REMARKS

APPENDIX A

AMENDMENT IN RESPONSE TO OFFICE  
ACTION DATED JUNE 23, 2005

Atty. Docket No. 100-23400  
(P05711)

**FIG. 3**

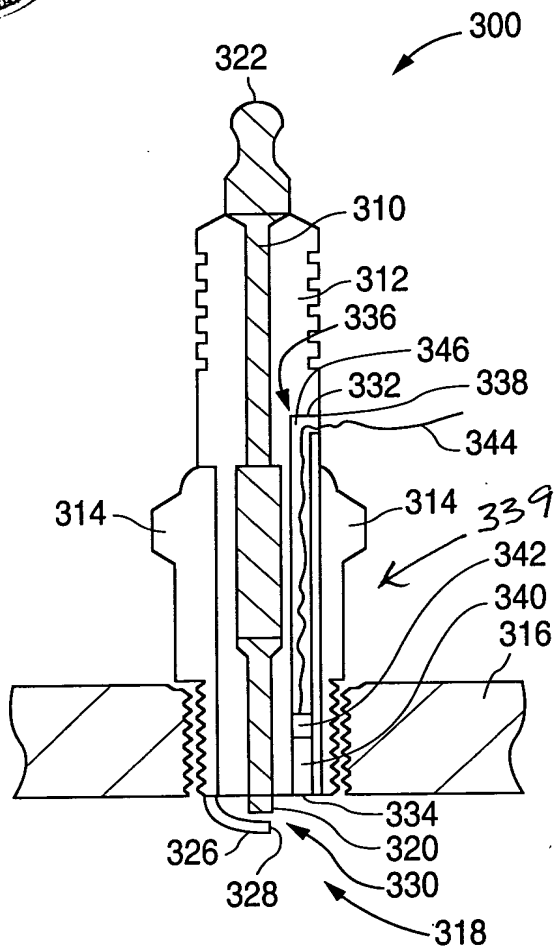
The Examiner objected to the drawings because reference number 339 is missing from FIG. 3. As a result, applicant proposes amending FIG. 3 to add reference number 339 as shown in red on a marked up copy of FIG. 3, which is attached in Appendix A. A replacement sheet including FIG. 3 is attached in Appendix B.

The Examiner also objected to the drawings because FIG. 3 does not show a hole with an L-shape as recited in claim 9. Applicant notes that hole 332, which is an L-shaped hole shown in applicant's FIG. 3, can be read to be the L-shaped hole required by claim 9. (See applicant's specification, page 4, lines 13-19.) As a result, it is believed that FIG. 3 shows an example of an L-shaped hole as required by claim 9.

With respect to claim 10, the Examiner indicated that it was unclear how the hole has an L-shape.

"In the example shown in FIG. 3, hole 332 is an L-shaped hole, although other shaped holes can alternately be used. L-shaped hole 332 begins at an opening 334 that lies adjacent to first end 320, and runs along a first line that is substantially parallel to the longitudinal axis of ceramic jacket 312 to a point 336 that lies on the outside of engine wall 316. From point 336, hole 332 runs perpendicularly away from the longitudinal axis to an opening 338 on the side of ceramic jacket 312." (See page 4, lines 13-19.)

**FIG. 5**

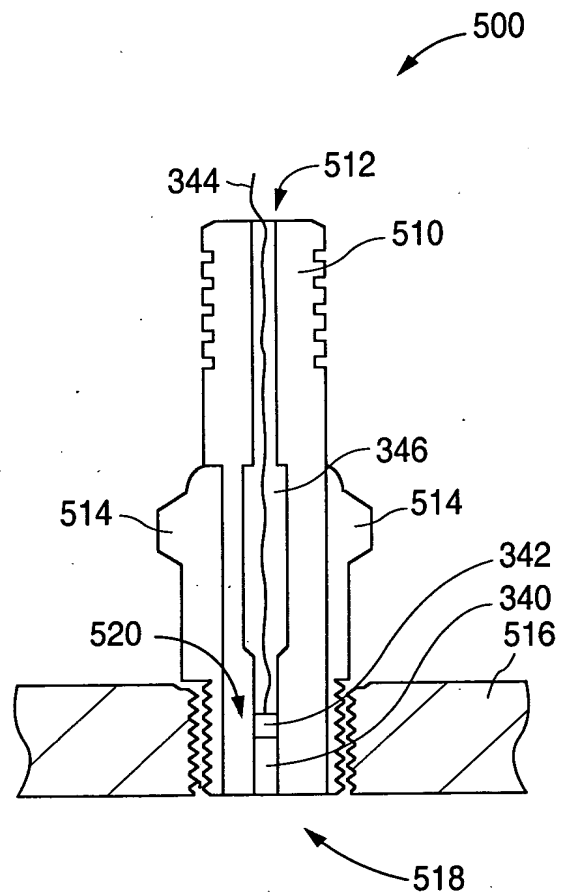
With respect to claim 11, the Examiner indicated that it is unclear how a hole can be substantially straight.

"In the example shown in FIG. 5, hole 512 is a straight hole, which has an end portion and a middle portion that is wider than the end portion, that runs along a line that is substantially coincident with the longitudinal axis of ceramic jacket 510, although other shaped holes in other locations can alternately be used." (See page 9, lines 1-5.)

Thus, from what applicant can determine, claim 11 is clear, and satisfies the requirements of the second paragraph of section 112.
